2001	Toshiba America Consumer Products, Inc.	Date: 4/9/2001
Product	Technical Bulletin	TVO101
PJTV		Ref. No. 40901

Subject: Correction to Service Manual (File No. 020-9913) and Summary (File No. 020-9923) concerning Service Mode Option settings.

2001	Toshiba America Consumer Products, Inc.	Date: 06/18/2001
Product	Technical Bulletin	TV0103
PJTV		Ref. No. 61801

2001	Toshiba America Consumer Products, Inc.	Date: 06/18/2001
Product	Technical Bulletin	TV0104
TV		Ref. No. 61801-2

(The following PCB layout is for normal scan.)

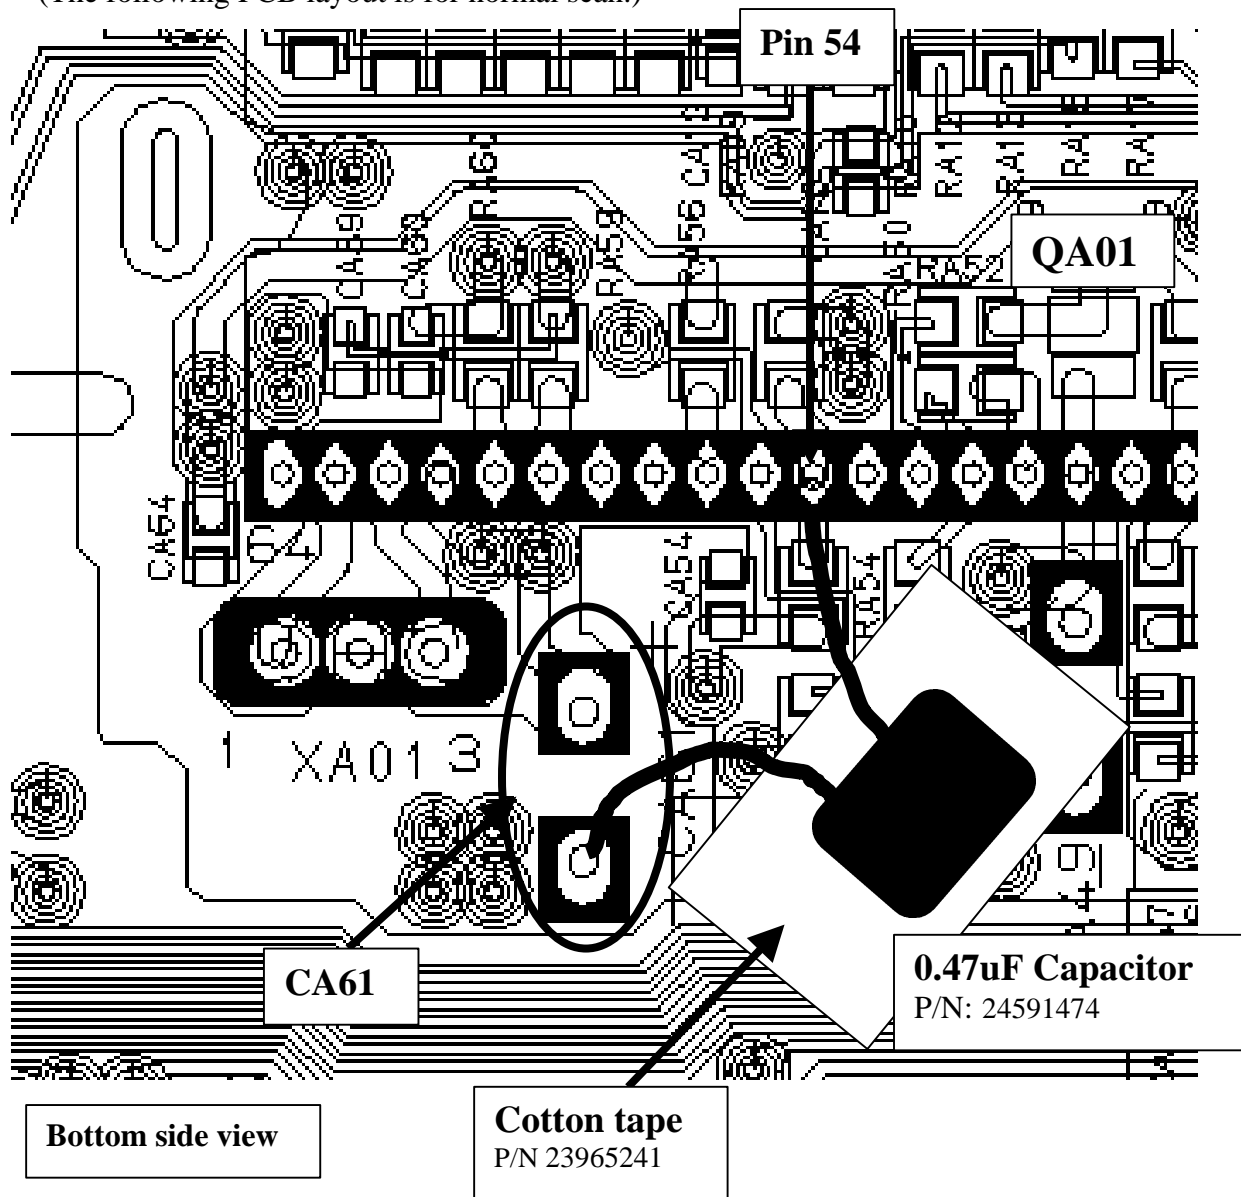
Subject: Circuit Modification

Symptom: Intermittent reset problems.
Example: Unit powers OFF and back ON.

Corrective Action: See diagram on Page 2.

Add cotton tape and a 0.47uF capacitor across QA01 pin 54 and GND (CA61 GND side).

Note: Although, the reset circuits and PCB layouts of normal (interlaced scan) and progressive scan units vary slightly, the location of QA01 and CA61 are almost the same.

Therefore, the instructions for both normal (interlaced scan) and progressive scan units are identical.

Diagram A

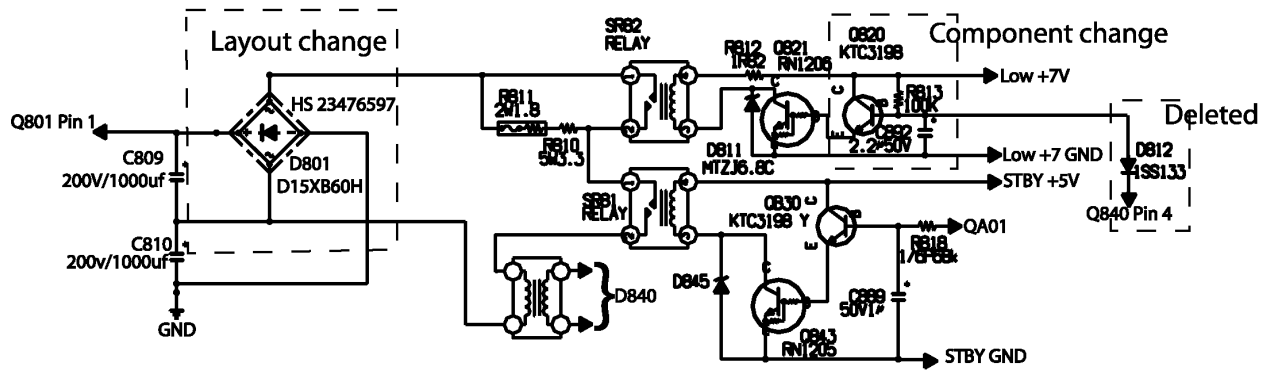
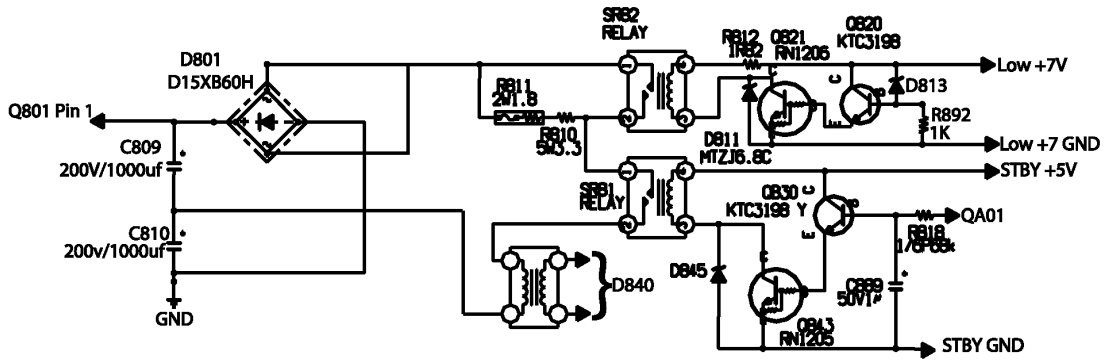
Subject: Relay drive circuit for progressive scan units.

Symptom: Schematic diagram, as drawn in service literature, is inconsistent with actual circuit layout.

Diagram A is the actual schematic drawing. The dashed lines border the affected areas.

Diagram B details changes made to reflect the actual circuit layout.
